**EPA Comments on  
Capture Zone Field Test Plan; GASCO, Portland, Oregon  
Prepared by Anchor QEA LLC  
Dated September 2009  
Comments dated October 8, 2009**

EPA's review and comments of the Capture Zone Test Plan focus on the information and references to construction and design details of the offshore piezometers. This information is found in Section 3.3, Figures 1 through 3 and Table 1 in the document, as well as pages 2 through 3 of Appendix A, which is a memorandum from Anchor QEA dated August 14, 2009. We have also reviewed responses from Anchor QEA in an email dated October 2 that responds to an ODEQ email dated September 30, 2009 that requested additional details on the existing and proposed offshore piezometers.

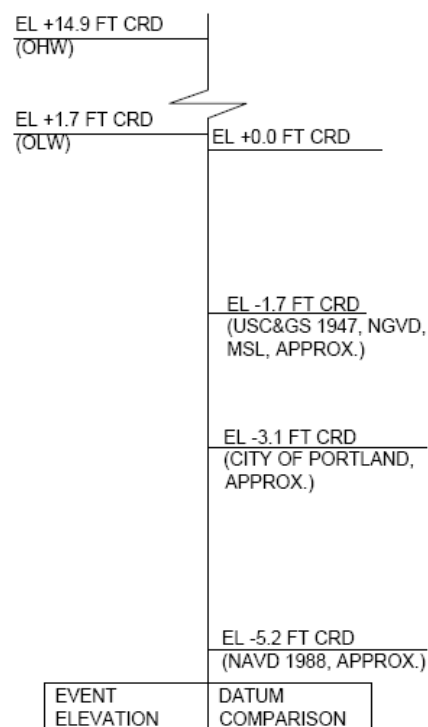
**Comment 8 – Table 1, Figures 2 and 3** – references to "msl" need to represent a consistent datum and be consistent with the Siltronic datum. Table 1 and Figure 3 indicate City of Portland Datum while Figure 2 has no datum reference. It is important that a consistent datum be used and cross referenced to known datums used in the area. An example of a cross reference is provided below from Port of Portland maps Early Action Characterization Report Figure 5-27, September 2004
